Re: Approval of the Revised Groundwater Assessment Plan (Permit #26-02).

IMPLEMENTATION PLAN
GROUNDWATER ASSESSMENT AND
CORRECTIVE ACTION
LONGSTREET ROAD MSW LANDFILL
(PERMIT # 26-02)
FORT BRAGG, NORTH CAROLINA

Revisions to WQAP

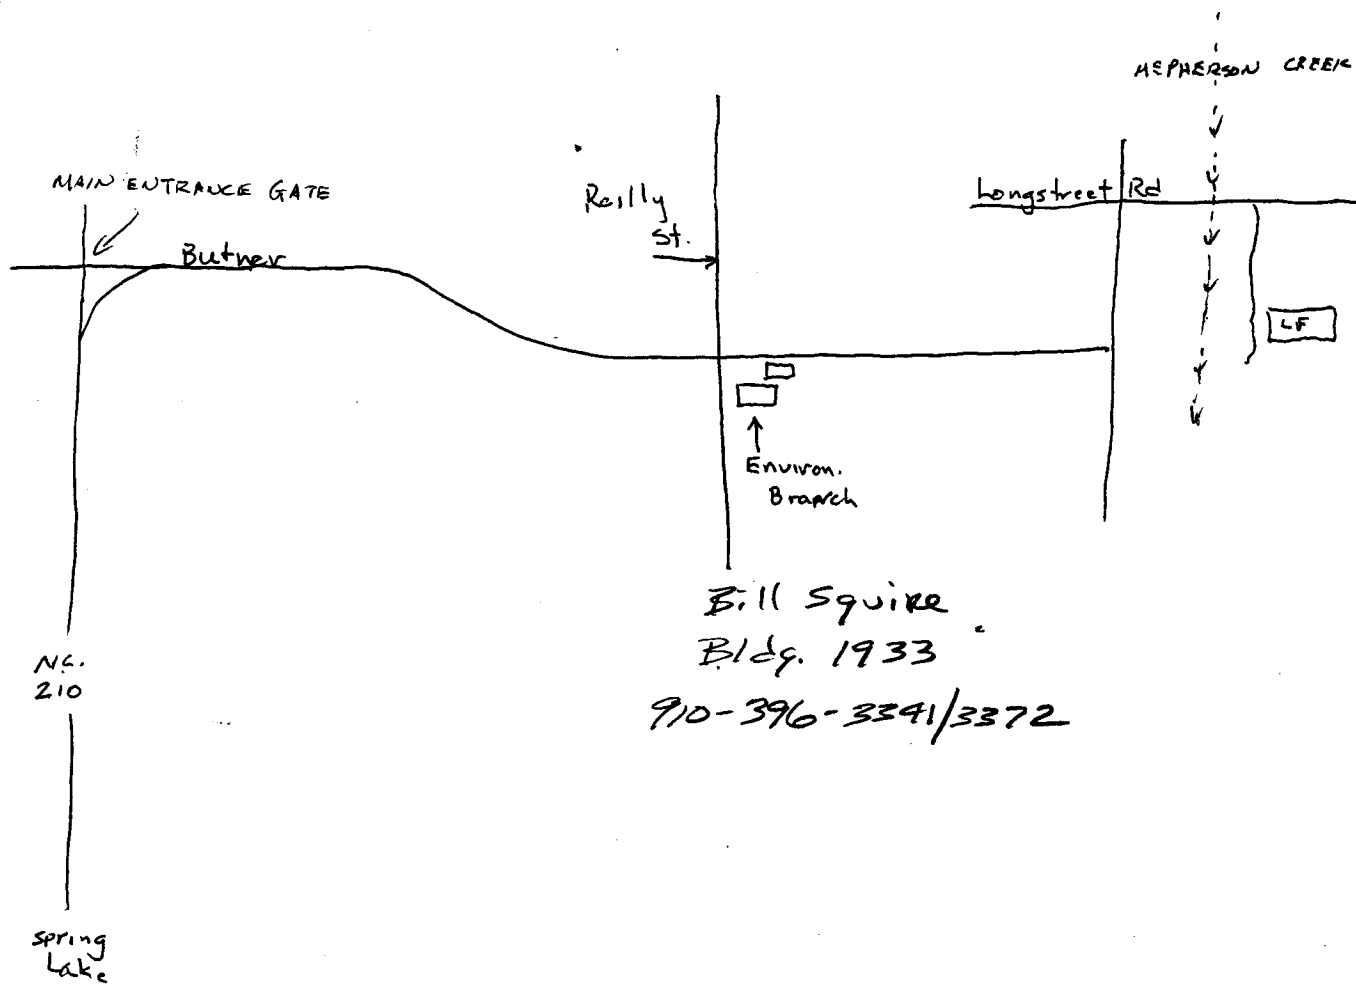
(confining unit?)

→ further explanation of telescoping
i depth.

Well completion records (with field logs). Will be completed in MWs?

sound permanent -

→ Need proposed locations
